Subject: AP1000 Response to Request for Additional Information (SRP 10)

RAI-SRP10.2-SBPA-02 R3

AP1000 TECHNICAL REPORT REVIEW

RAI Response Number: RAI-SRP10.2-SBPA-02
Revision: 3

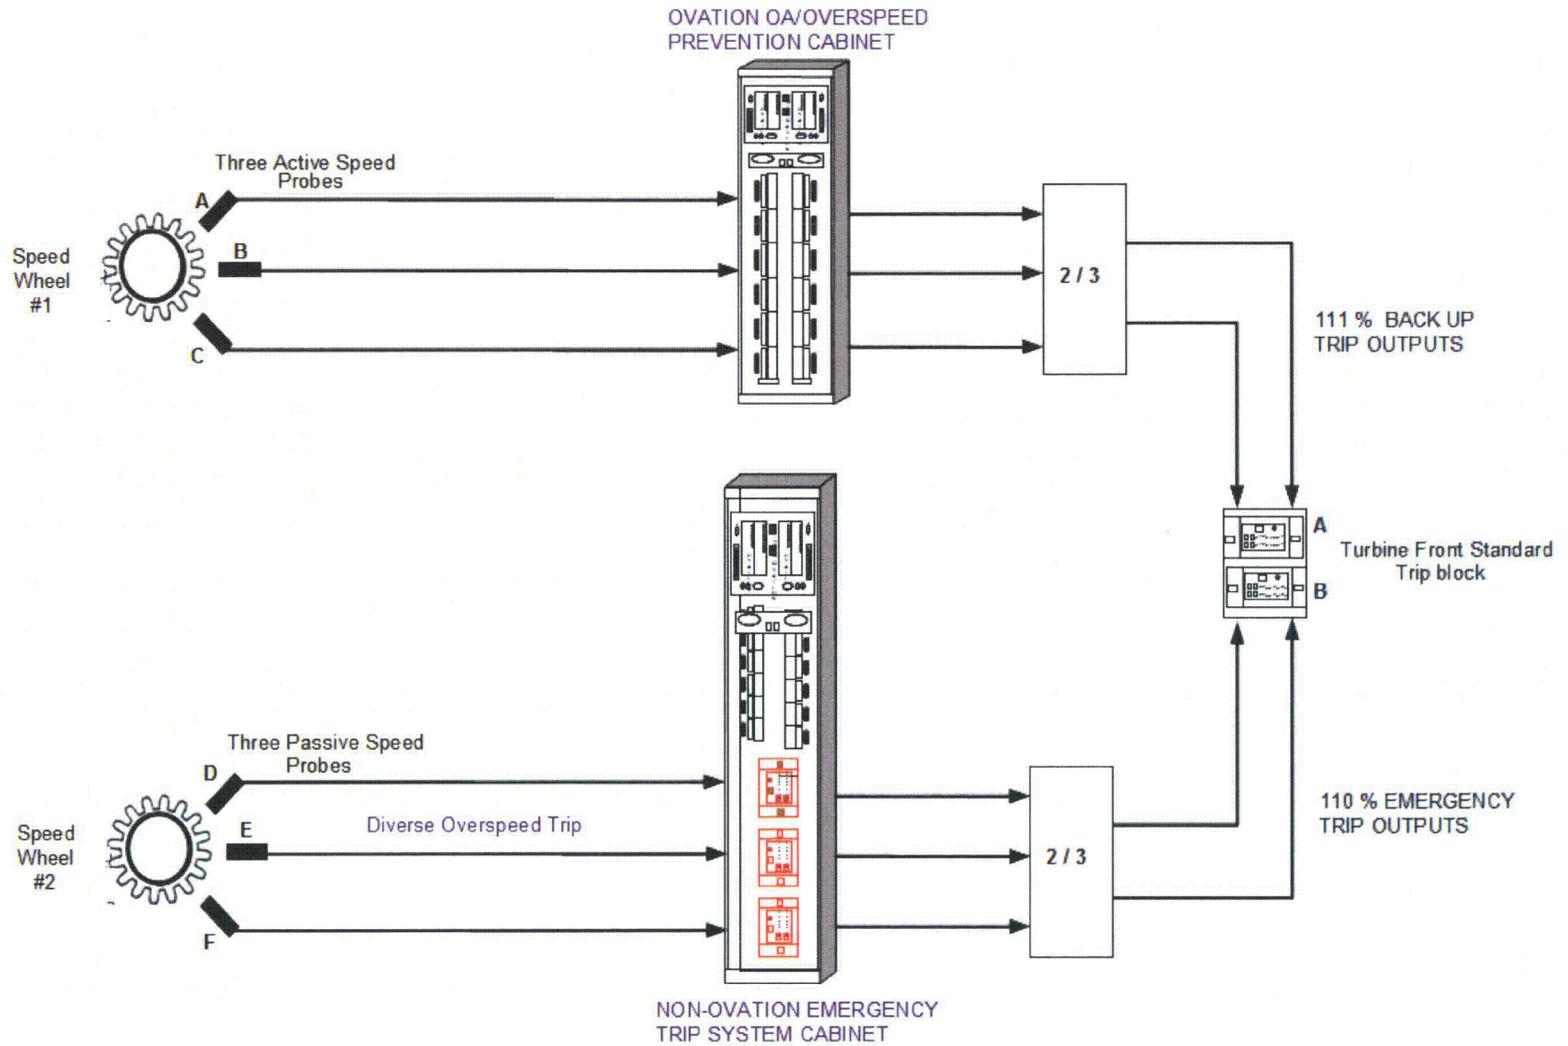
Regarding the Westinghouse response to RAI-SRP10.2-SBPA-02 R2 (DCP NRC 002647, October 7, 2009), the staff feels that Tier 2 updates should include your diversity design description and the letter's figure. Tier 1 updates appear complete.

The DCD changes proposed below show and clarify that the 110% and 111% trip systems have diverse hardware and software/firmware to eliminate common cause failures (CCFs) from rendering the trip functions inoperable. A diagram is provided below to show the system configuration with a non-Ovation controller for the diverse 110% emergency trip system.

3. The figure showing the diversity design provided in Revision 2 of this response is improved and added below as a new DCD Figure 10.2-2, "Emergency Trip System Functional Diagram."
